# UNITED STATES PATENT AND TRADEMARK OFFICE

| APPLICATION NO.  | FILING DATE | FIRST NAMED INVENTOR | ATTORNEY DOCKET NO.         | CONFIRMATION NO.       |
|--|-------------|----------------------|-----------------------------|------------------------|
| 10/561,978   | 12/22/2005  | Gerhard Winiger      | 11201/20                    | 1621                   |

| <b>Office Action Summary</b> | <b>Application No.</b><br>10/561,978 | <b>Applicant(s)</b><br>WINIGER, GERHARD |  |

## **DETAILED ACTION**

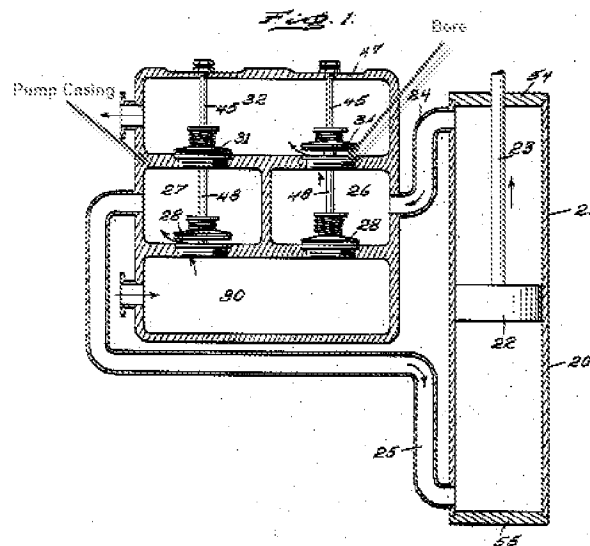
In regards to claim 11, Boakes discloses a double acting reciprocating pump (20). It can be seen in Fig.1 that a piston (22) is provided with in a working chamber (21) that is narrowed due to the relative movement of the piston (22). Boakes discloses further, two parallel bores, arranged parallel to the pump cylinder (21), and formed in the equivalent portion to what examiner is considering as the pump's casing (see Fig.1 label by the examiner for clarity). It may be understood from the illustration of Fig.1 that the bores serve as inlet and discharge pipelines in that they provide a passage for fluid flow. Fig. 1 shows that each bore is pierced by a valve rod (48), in which valves (28,

31) are provided at both ends of the rod (48). Boakes discloses that during the operation of the reciprocating pump, as the piston moves towards the end (54) of the pump cylinder, regarded by the examiner as an equivalent to an "extreme position" as indicated by the applicant, the valve (31) opens and valve (28) closes. Furthermore, when the piston has completed its stroke and moves in the opposite direction towards end (55), or the opposed extreme position, there is a reversal in the motion of each valve (see column 3, lines 51-68 and Fig.1).

In regards to claim 13-14, Boakes discloses that valve rod (45) is threaded and it may be seen from Fig.1 that a nut (labeled by the examiner) is provided at the end of the valve rod facing an equivalent structure to that of a valve lid (labeled by the examiner). Boakes discloses that the valve rod adjustably threads which meets the limitations of the claim as best understood (see column 3, lines 13-16 and Fig. 1).

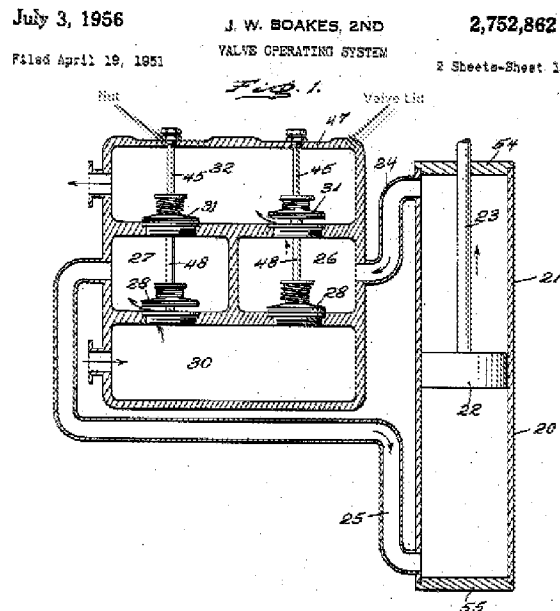
In regards to claim 12, Reichmann shows in the illustration in Fig. 1 valve rods (labeled by the examiner) which pierces the valves ( $b^1$  and  $b^2$ ), the pump casing (labeled by examiner) and the valve lid (labeled by examiner). It can be seen that the valves ( $b^1$  and  $b^2$ ) are connected to a lever (b), equivalent to that of a compensator as designated by the applicant, in which the lever (b) or compensator moveably connects the valve rods to conveying lever (a) by a plate (label by the examiner).

With respect to claims 15-18 it can be seen in Fig. 1 that the reference according Reichmann has the ability to synchronously driving a plurality of piston pumps, according to Boakes in view of Reichmann, by coupling their propelling levers ( $a^1$  and  $a^2$ ) to a common piston rod. In regards to claims 19-22, the disclosure according to Boakes in view of Reichmann also provides the ability to allow for the vertical arrangement of the piston pumps.
